Intel[®] I/O Controller Hub 6 (ICH6) Family

Specification Update

May 2012

Order Number: 301474-030

Figure 1. LPC Bridge SERR# Generation

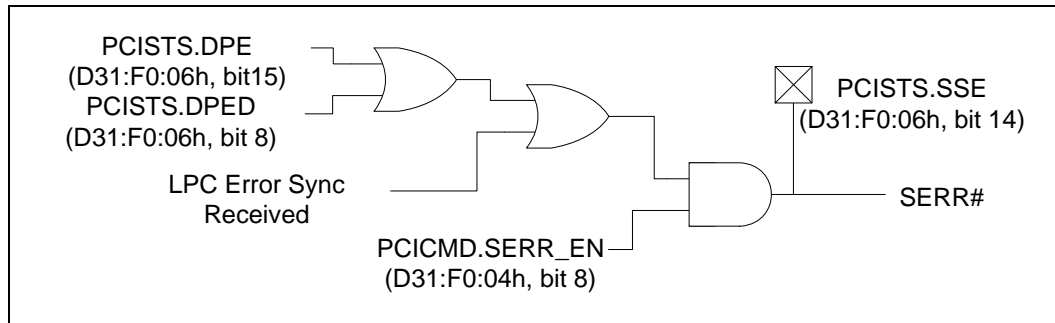
The following text is added to the bottom of Chapter 6 (before section 6.1):

The first class of errors is parity errors related to the backbone. The LPC Bridge captures generic data parity errors (errors it finds on the backbone) as well as errors returned on the backbone cycles where the bridge was the master and parity error response is enabled. If either of these two conditions is met, and with SERR# enable (PCICMD.SERR_EN) set, SERR# will be captured.

Additionally, if the LPC Bridge receives an error SYNC on LPC bus, an SERR# will also be generated.
